TODD ACRES SUBDIVISION, SIXTH UNIT,
RESUBDIVISION LOTS 5&6

APPLICATION NUMBER 18 DATE July 10, 2008

DETAIL SITE PLAN

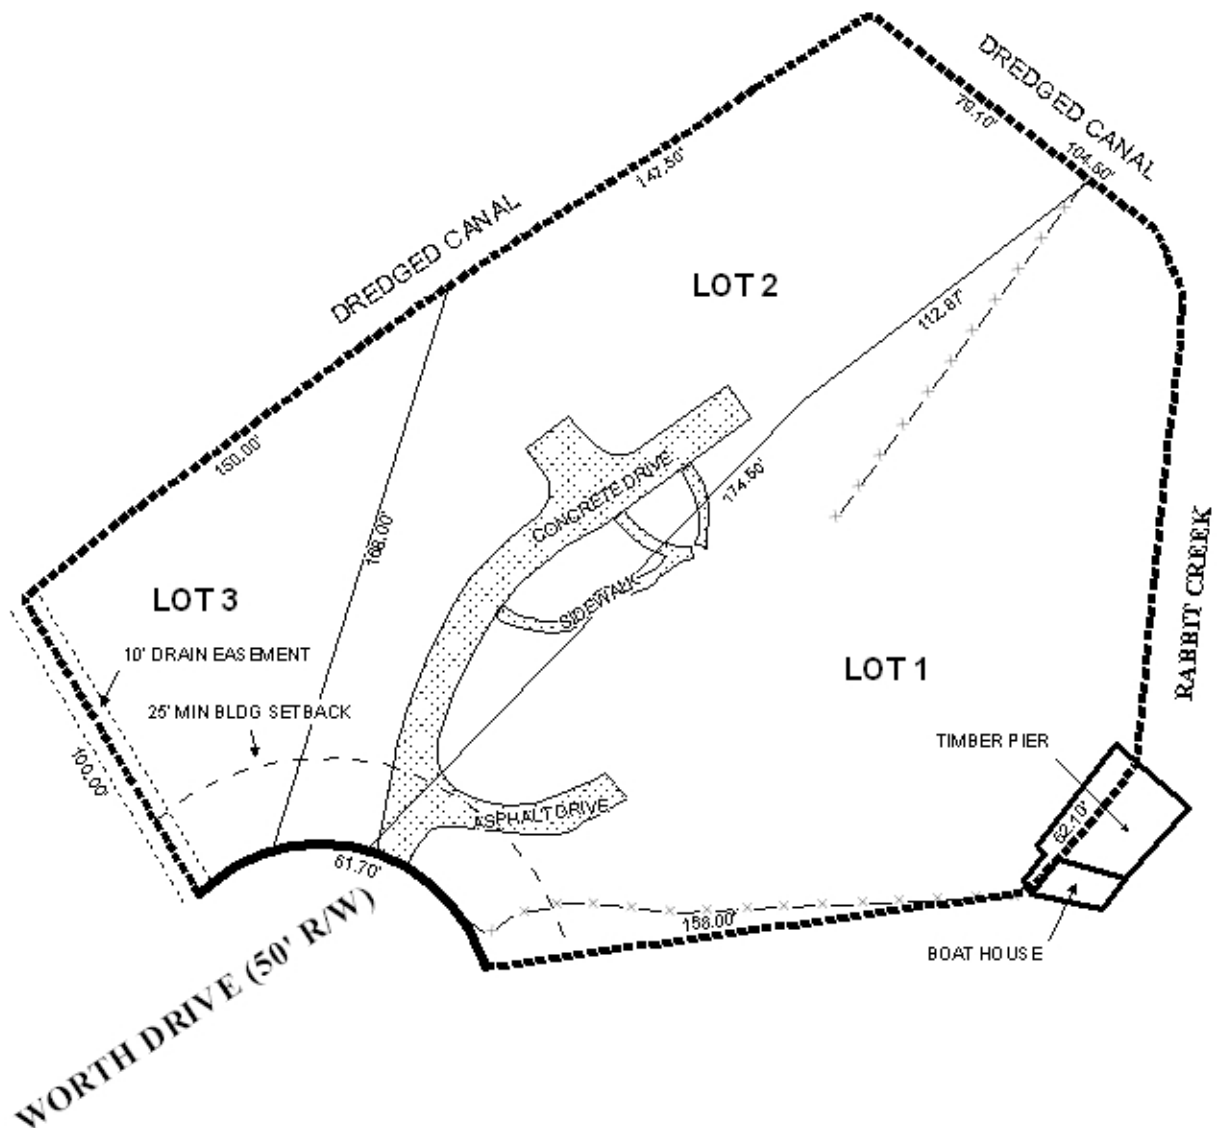
The site fronts a cul de sac at the terminus of Worth Drive with 100' of right-of-way. Section V.B.14. of the Subdivision Regulations, as amended 4/3/08, now requires cul de sac rights-of-way to be a minimum 120' to accommodate the 2003 International Fire Code. Since the cul de sac was in existence before the amendment and only a portion is being re-subdivided, it would be impractical to enforce this requirement at this time.

As proposed, Lots 1, 2, and 3 have approximately 51, 27, and 25' of frontage, respectively, along Worth Drive. As a means of access management, a note should be placed on the final plat stating that each lot is limited to one curb, with the size, location, and design to be approved by Traffic Engineering and conform to AASHTO standards.

Section V.D.2. of the Subdivision Regulations requires that lots for residential use to be at least 60' in width at the minimum building setback line, exclusive of drainage easements. Again, the plat should be revised accordingly.

The plat meets the minimum size requirement for developments with access to public water and sewer. However, it is requested that the applicant revise the preliminary plat to label the lot with its size in square feet, or provide a table on the plat with the same information.

It appears that wetlands exist on a portion of the site. The presence of wetlands and floodplains on the site indicate that the area may be environmentally sensitive; therefore, the approval of all applicable federal, state and local environmental agencies would be required prior to the issuance of any permits or land disturbance activities

- 1) revision of the plat to provide 120' of right-of-way for the cul de sac at the terminus of Worth Drive, as required by Section V.B.14. of the Subdivision Regulations and the 2003 International Fire Code;

- 2) placement of a note on the final plat stating that each lot is limited to one curb cut, with the size, location, and design to be approved by Traffic Engineering and conform to AASHTO standards;

- 3) revision of the minimum building setback line for each lot to comply with Section V.D.2. of the Subdivision Regulations;
- 4) labeling of each lot with its size in square feet, or the provision of a table on the final plat with the same information;
